# SERVICE BULLETIN

SERVICE DEPARTMENT  
**DODGE**

No. D-37

Defroster  
Control

FIGURE 1

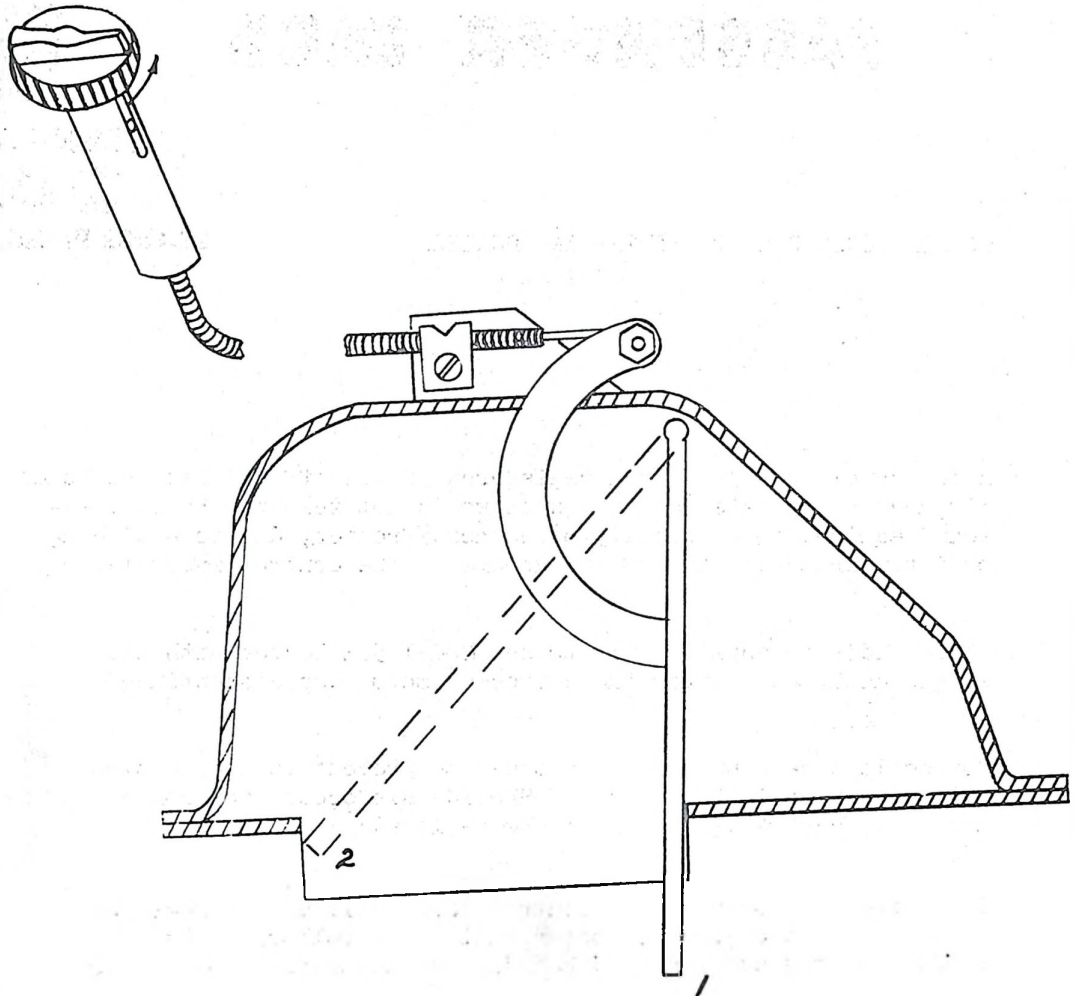
Improper adjustment of the control cable will also affect the full operation of the defroster unit. The following sketch shows how this cable should be adjusted at the control valve.

The control knob should turn approximately one (1) full turn in order to close or open the defroster valve.
